Walk Ride Bath - Bath Walking Wheeling Cycling Links Response

Introduction

| Weston High Street..... | 7 |

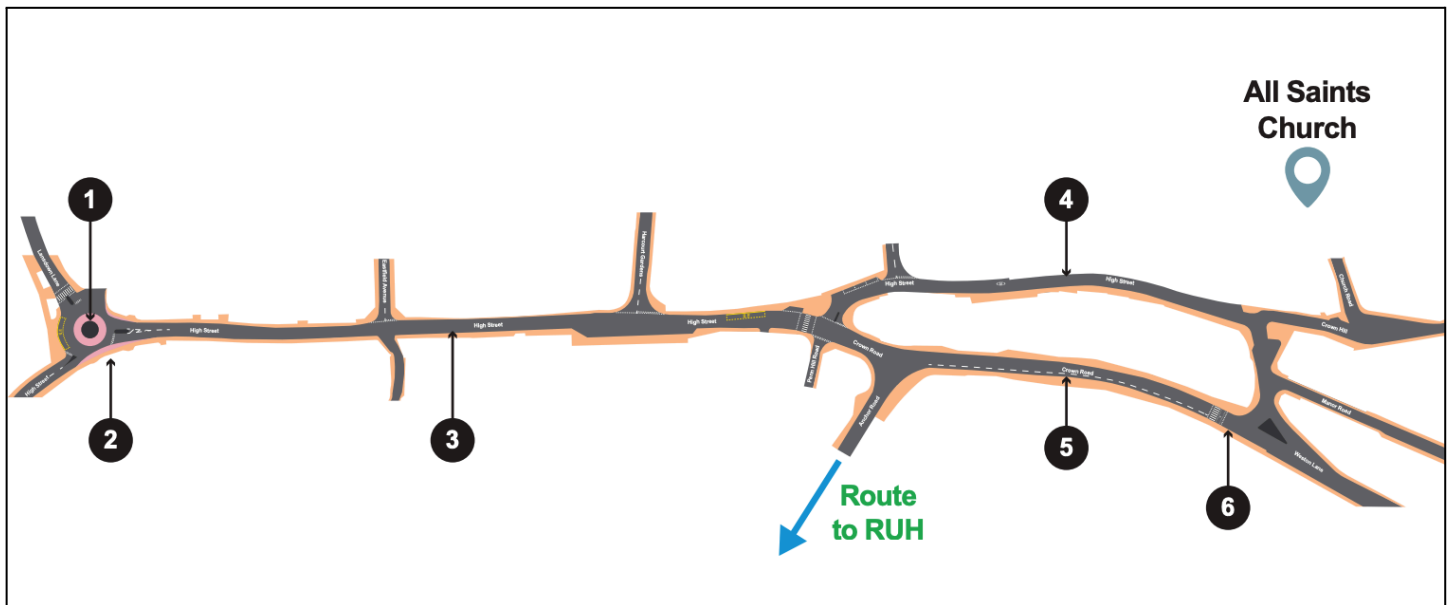
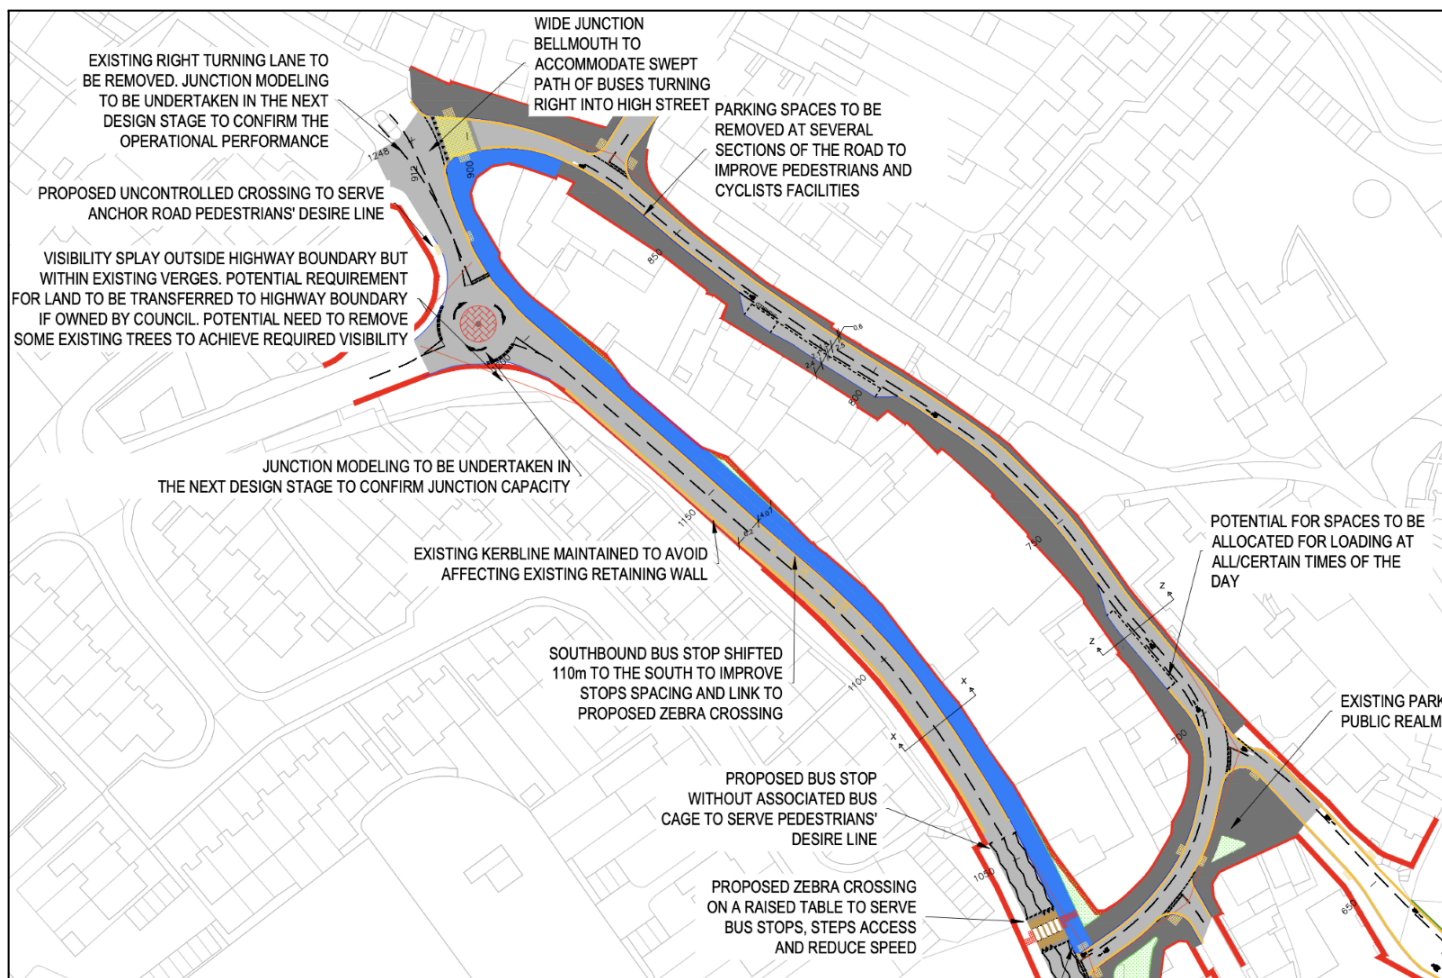
Good to see Penn Hill Road (No 1-10) changed to provide a contraflow for cycles.

The Crown Road advisory cycle lane should be removed as such 'advisory lanes' are considered dangerous.

The council should consider AECOM's High Street designs, mindful of recent [regeneration works](#). AECOM proposed two routes for connecting Penn Hill Road to Crown Hill:

| Crown Hill, Weston Park..... | 8 |

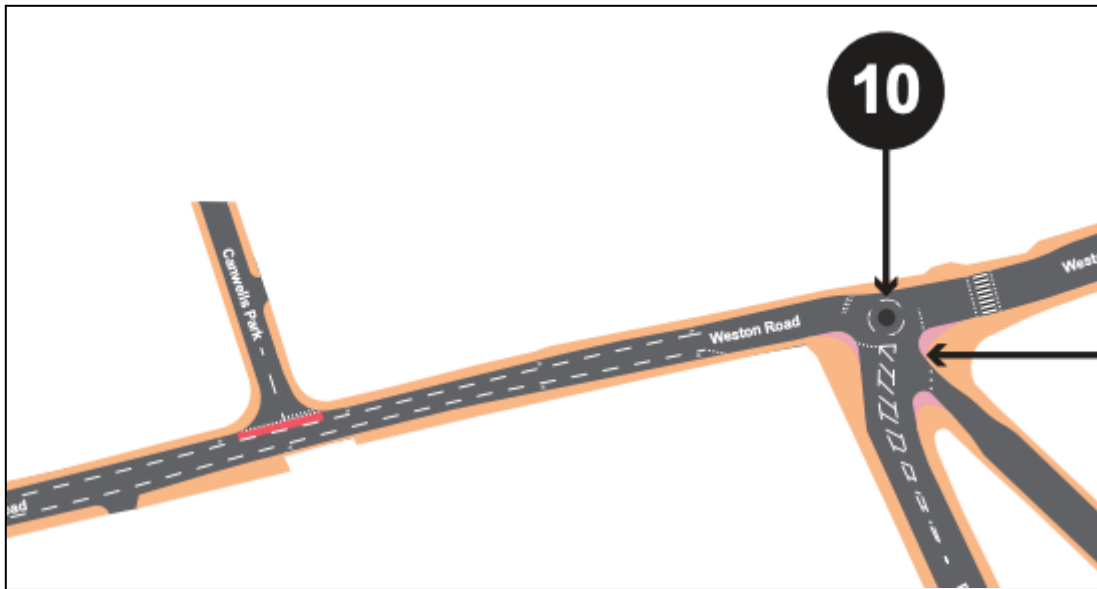
WRB supports this proposal if the route conforms to [LTN 1/20](#) mixed traffic scenarios (P 33 Fig 4-1) levels of vehicular traffic.

| Weston Road..... | 9 |

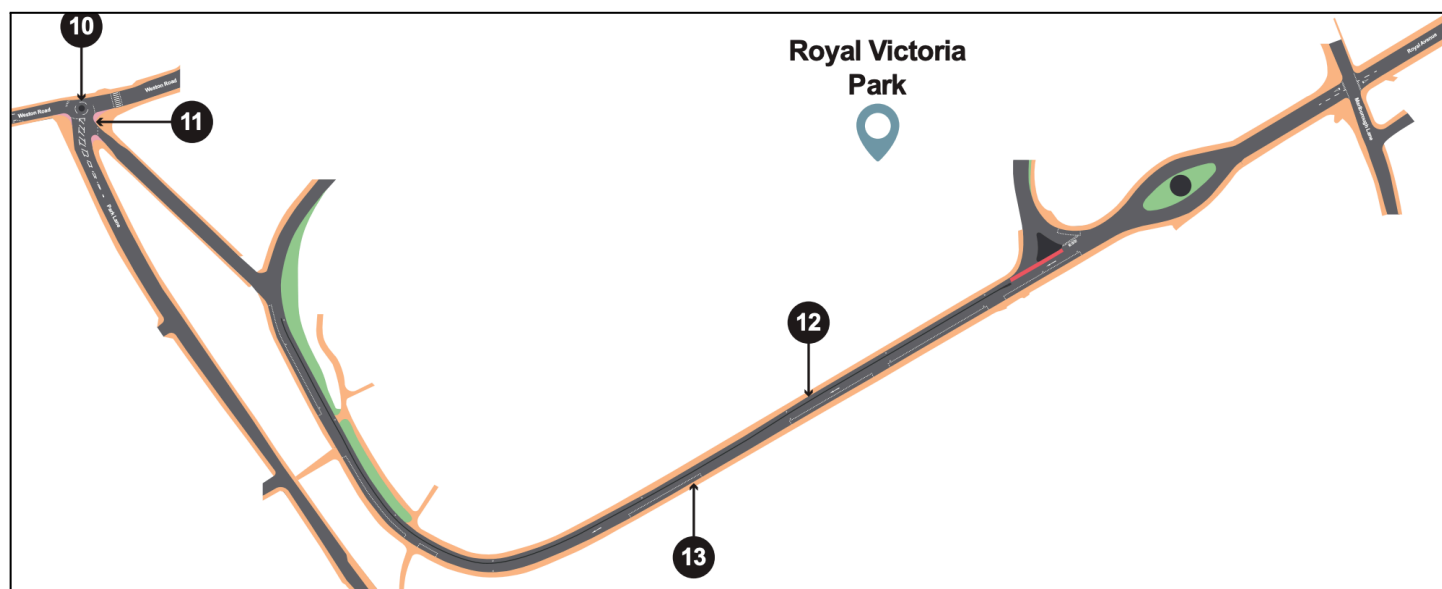
Use of advisory cycle lanes makes Weston Road potentially more dangerous for cyclists. We do not support their use and request these be removed from the design. The solution for Weston Road is considered to be a mixed traffic scenario (<2000 vehicles per day). We believe this would require a bus gate on Weston Road given that there are over 8,000 vehicle per day movements on Weston Road and the 85 percentile speed is 29mph ([Aecom B&NES Highway Safety Improvement Studies October 2022](#)).

An artist's impression of a segregated contra-flow cycle track, based on our preliminary designs.

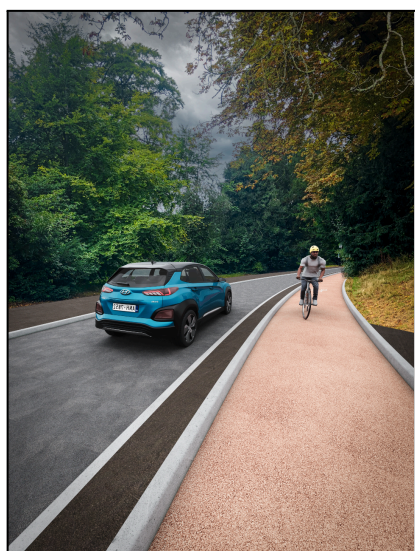
Closing vehicular access to Victoria Park at Park Lane is cautiously welcomed. Isolated park routes are not safe for women to use after dark and we question why this route was chosen in the first place.

The orbital route is not high in motorised traffic volume, and this *leisure* route is considered sufficient for the majority wheeling and cycling, with those travelling east/west using the southern section, and those travelling

west/east using the northern section. The vehicular closure at Park Lane will further assist this. The cost of construction of the cycle lane would be better utilised elsewhere. eg – See [Appendix C: Queen Square](#).

Street lighting along the orbital route, similar to the lighting improvement proposed for Royal Avenue, should be considered. Even with the lighting, the route is unlikely to be used to its full potential, particularly by women and children in hours of darkness.

- Delivering closure of vehicular access to Victoria Park as this provides the majority of the benefits of the park route.
- Delivering LCWIP Bath Route 1 Section 3 providing much safer, higher community and strategic benefits for the north of Bath at potentially lower cost.

| Royal Victoria Park to Queen Square..... | 11 |

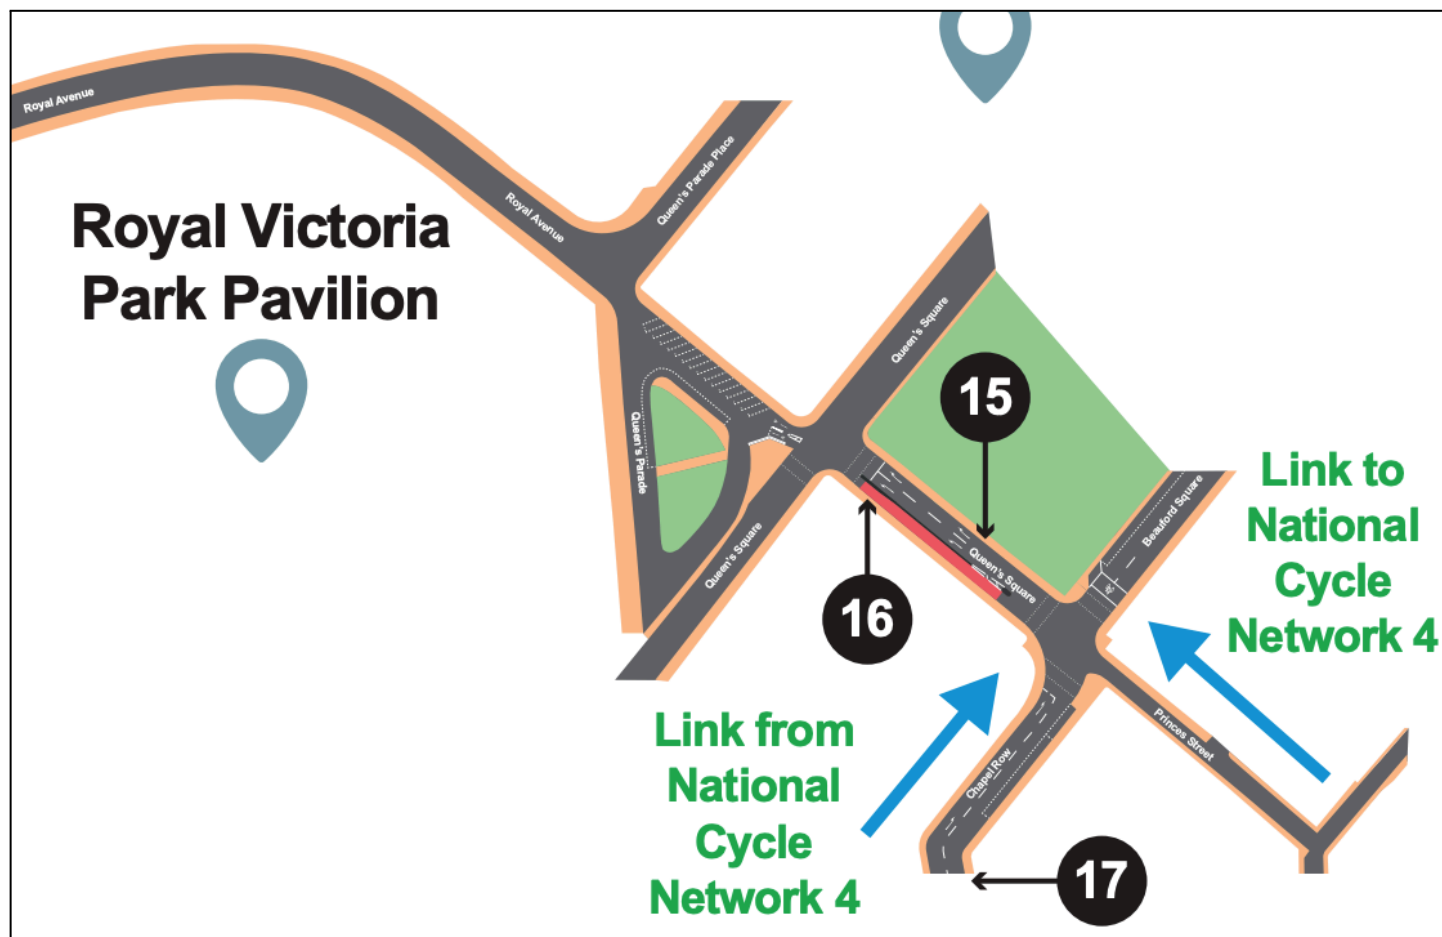
The detail of the street lighting is critical. To make Royal Avenue socially safe for active travel requires a full set of street lights along its full length. Such lighting should be sensitive to the surrounding ecology.

The level of traffic along Royal Avenue should be monitored to ensure the road complies with LTN 1/20 - Mixed Traffic scenario. A modal filter should be considered if this is not the case.

The council should consider widening the path between Brock Street and Royal Avenue and installing better signposting on Royal Avenue. This strengthens the argument for delivering LCWIP Bath Route 1 Section 3.

| Queen Square..... | 13 |

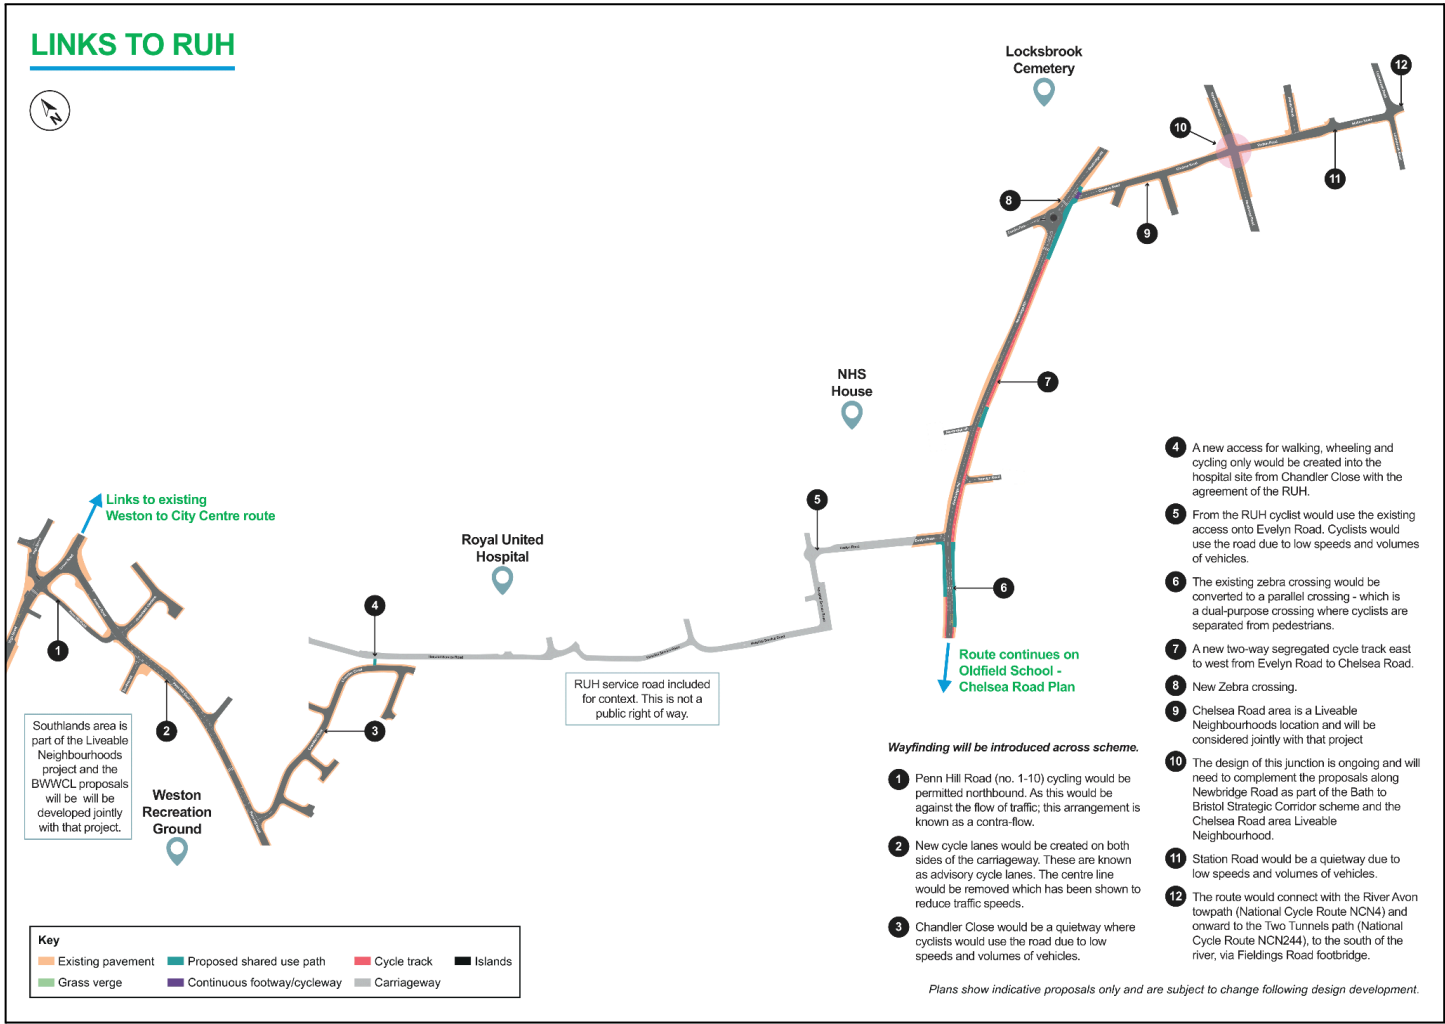
Queen Square is a potentially wonderful part of the public realm, but is currently inaccessible to many, including the young, elderly, disabled, and those with visual impairments, due to the surrounding roads being open to motorised traffic.

WRB suggests an alternative solution for Queen Square in [Appendix B: Queen Square](#) that elegantly addresses these issues and design conflicts.

| Weston High Street to RUH..... | 14 |

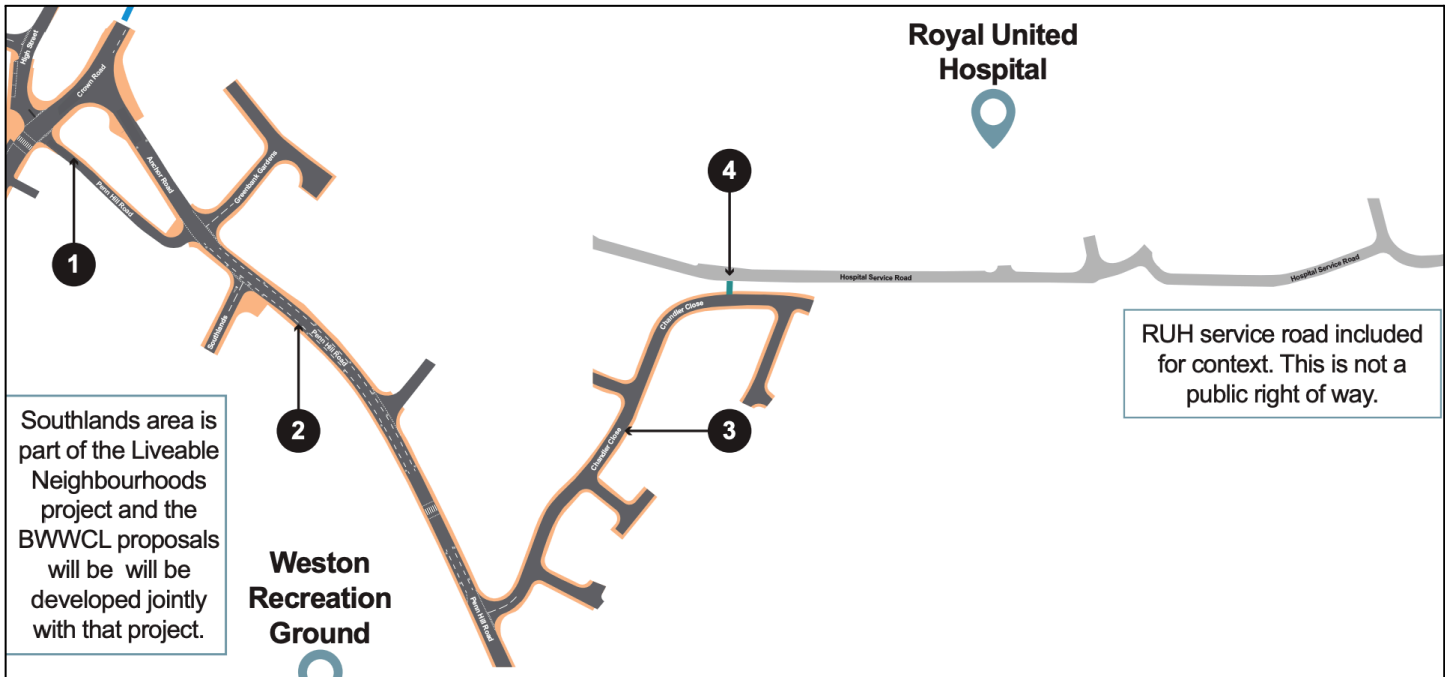
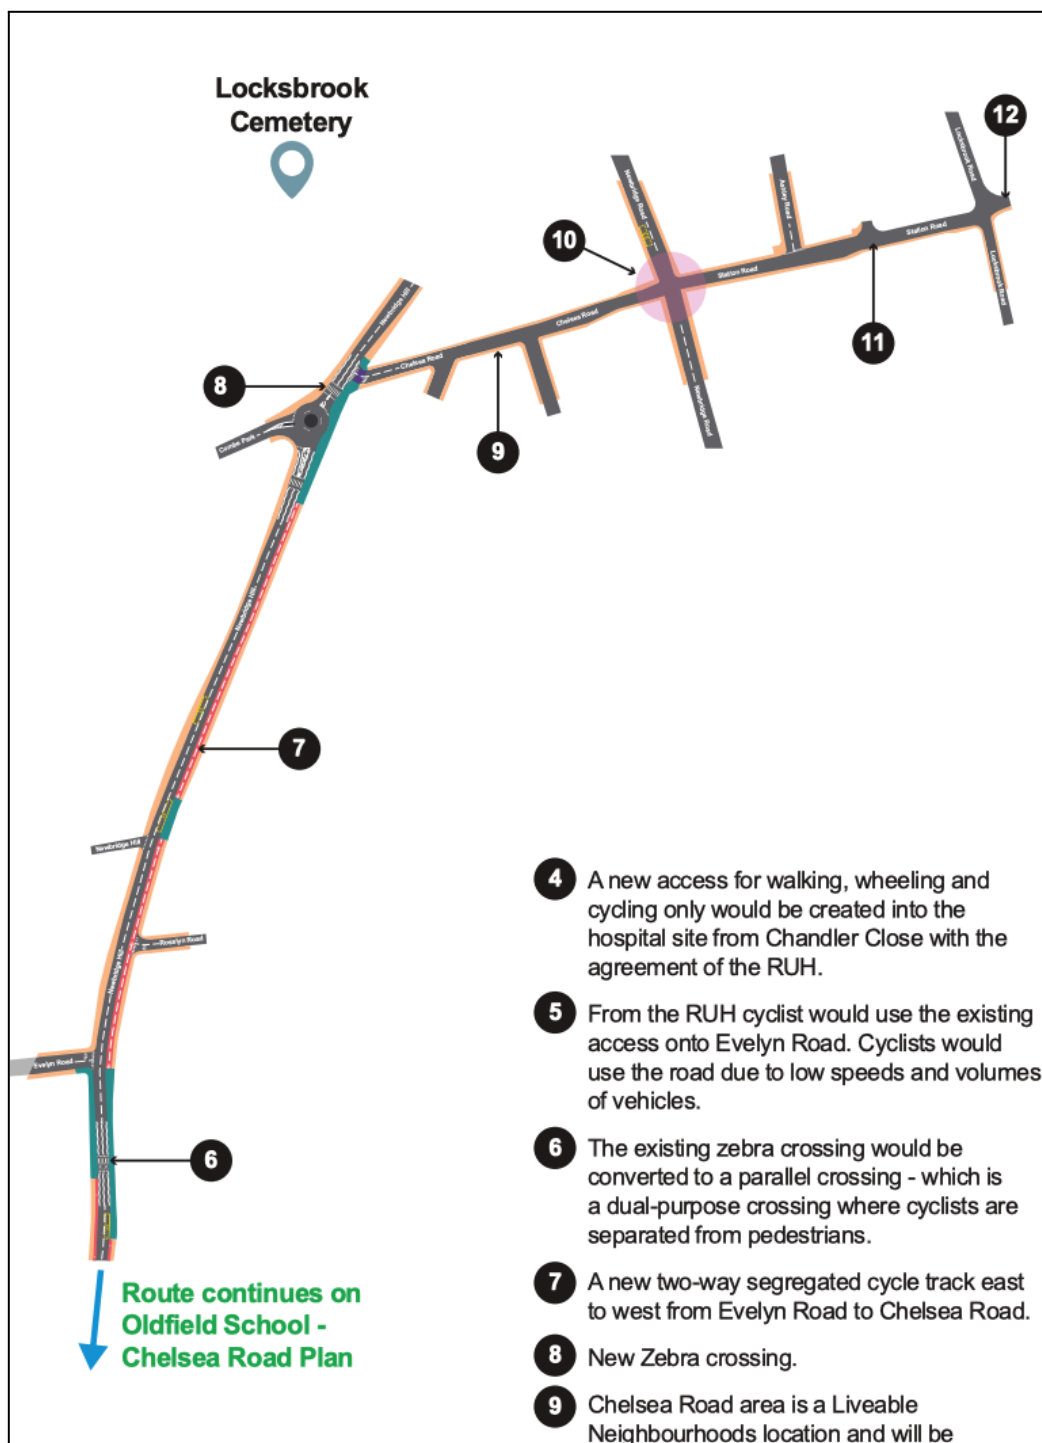
We support the proposal for Penn Hill Road (no. 1-10).

The use of advisory cycle lanes increases danger to cyclists and we do not support their introduction on Penn Hill Road. Given the volume of traffic on Penn Hill Road, we propose that a cycle track or wide shared path is built on the west side of Penn Hill Road creating a cohesive connection from Kelston Road (A351) to Crown Road connecting into the Newbridge Hill scheme (and potentially to the Park and Ride).

We suggest that the access to the RUH via Chandler Close is overly complicated when the RUH Gate 3 access road already serves this function. We recommend working with the RUH to install a cycle contraflow.
